# **Construction Industry Coalition on Water Quality**

September 14, 2015

RE: Comment - Tentative Order No. R9-2015-0100, Place ID: 686088WChiu

Photo 1 – La Jolla Landslide (Ardath Shale Formation, Claystone, Hydrologic Group D)

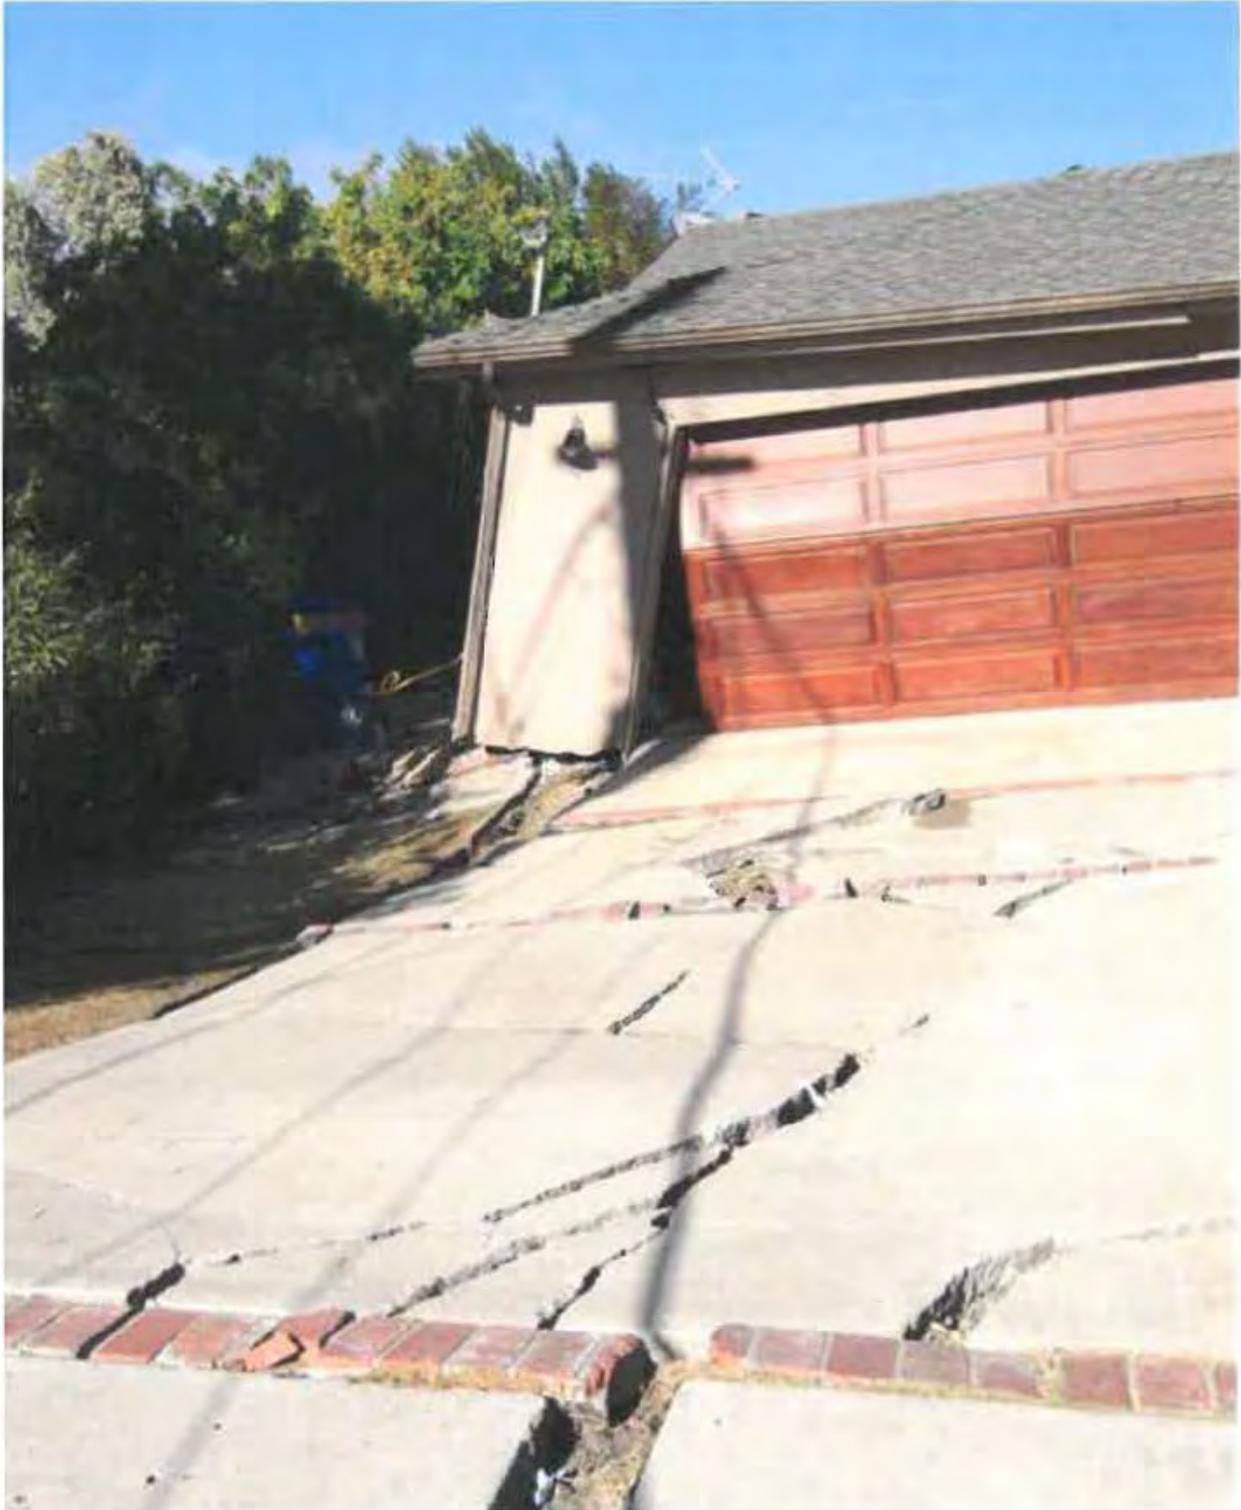
The soil types in Region 9, and particularly San Diego County, are likely infeasible for infiltration where stormwater could eventually reach the underground aquifer. More than 70 percent of the soil types found in San Diego County possess a Soil Hydrologic Group classification of C and D (USDA, 1973). A large majority of the land area possesses a classification of C or D (SANDAG, 2007) and soft/hard rock (CGS, 2007). Using infiltration as a preferred method of stormwater remediation county-wide, therefore, is unsupported. Clearly stated, in the appropriate soil type, infiltration is a preferred alternative. In the wrong soil type the results could be catastrophic. (See photos 1 & 2).

Photo 7 mid-rise condo project at the NW corner of 4th and Nutmeg, San Diego

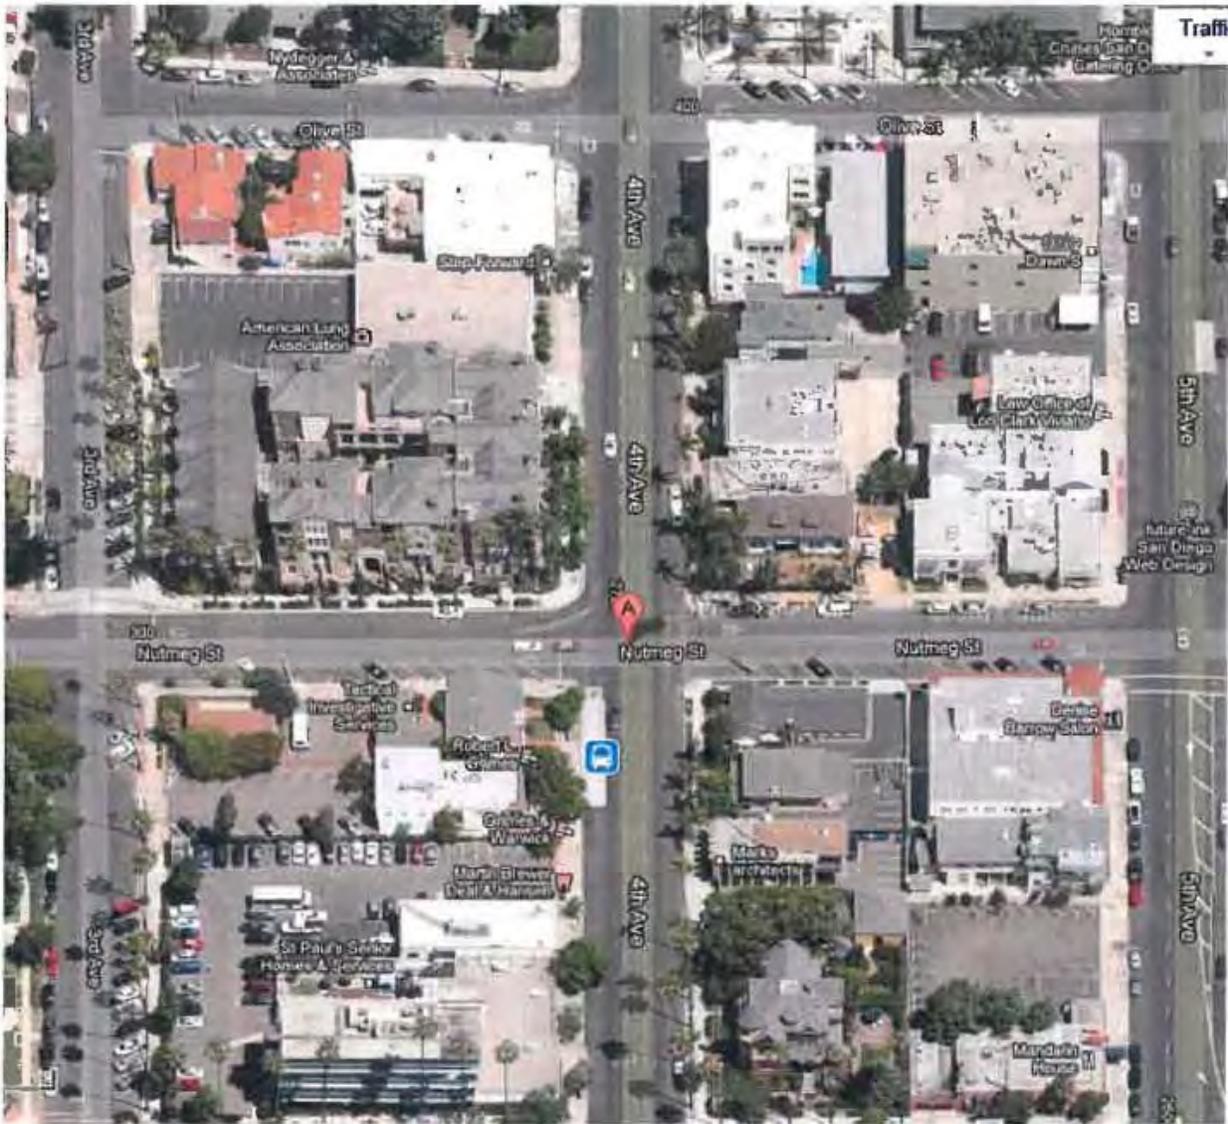
hydromodification exemptions on infill development render these projects both technically and financially infeasible. (Refer to photograph 7.)

Photo 7 shows a smart growth project on the northwest corner of 4th & Nutmeg in San Diego's highly urbanized Banker's Hill neighborhood: transit friendly (transit oriented development, TOD); walkable neighborhood; near parks, shopping and recreation (2 blocks from Balboa Park); near San Diego's airport; near Downtown/Hillcrest/Mission Valley work environments; and within the Smart Car (car 2 go) user footprint. Under the Revised Draft Permit, this project would become infeasible because of the 100% pollutant capture (infiltration/reuse) requirement and the loss of the hydromodification exemption previously included in the HMP.
